STRATEGIC INFRASTRUCTURE DEVELOPMENT
APPLICATION TO AN BORD PLEANÁLA
(REG NO. PL04.PA0045)

RESOURCE RECOVERY CENTRE,
RINGASKIDDY, COUNTY CORK

WITNESS STATEMENT OF AVRIL PURCELL

ARCHAEOLOGY ARCHITECTURE & CULTURAL HERITAGE

ELEVATION ALONG MAETELLO TOWER PATH

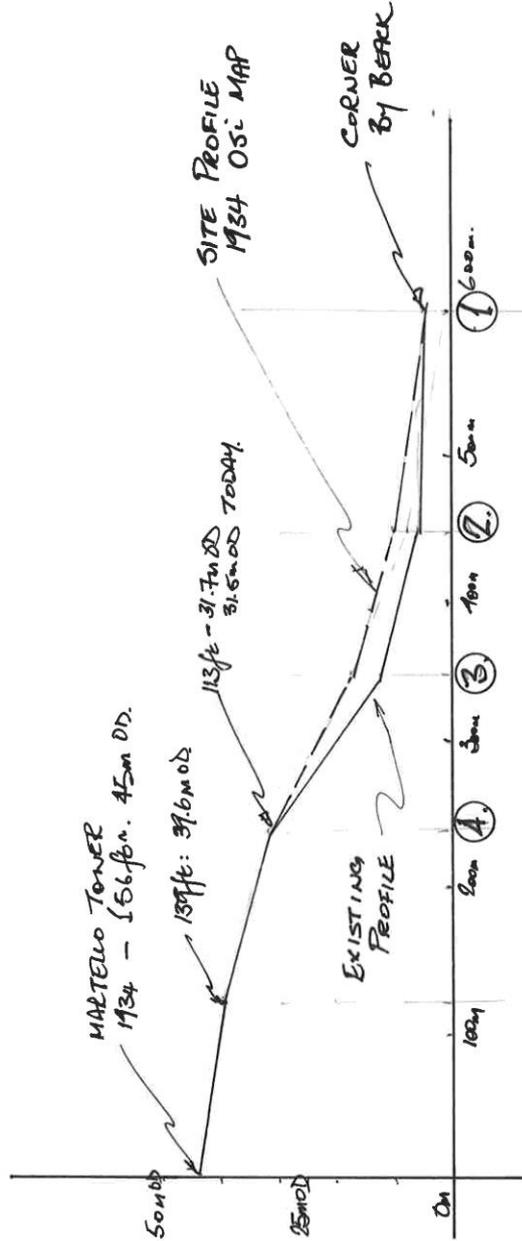
1. Clarification should be sought in the form of pre-development archaeological testing to establish the presence or absence of the historic path between Gobby Beach and the Martello Tower.

The applicant is proposing to carry out licensed geophysical survey and licensed archaeological testing prior to construction commencing. Given the weight of evidence that the path does not survive it is suggested that the pre-development archaeological investigations proposed would be sufficient to address this point.
